SIB 65 27 23

2023-11-20

APPLE CARPLAY® VARIOUS OPERATIONAL FAULTS

This Service Information Bulletin (Revision 1) replaces SI B65 27 23 dated **September 2023**.

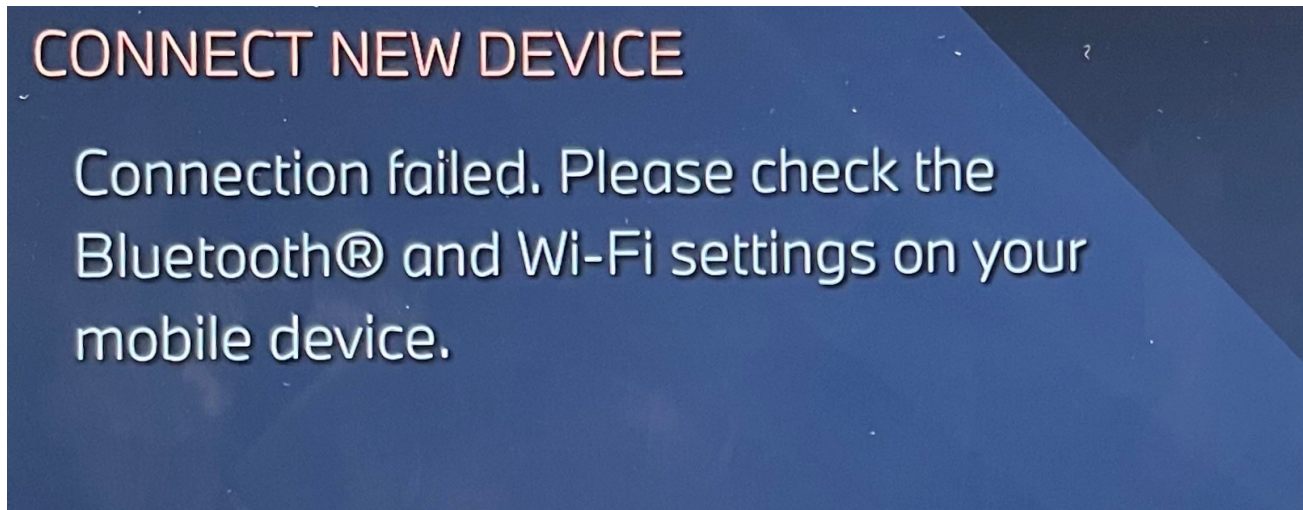
Customers may be experiencing one or more of these 3 issues with Apple CarPlay® operation:

- No selections can be made in Apple CarPlay® using the I-Drive Controller
- Apple CarPlay® connections may intermittently be dropped and reconnected
- When connecting a mobile device using Apple CarPlay®, the following warning pop-up may be displayed

Unfavorable software in the head unit (HU-H5).

Program the head unit (HU-H5).
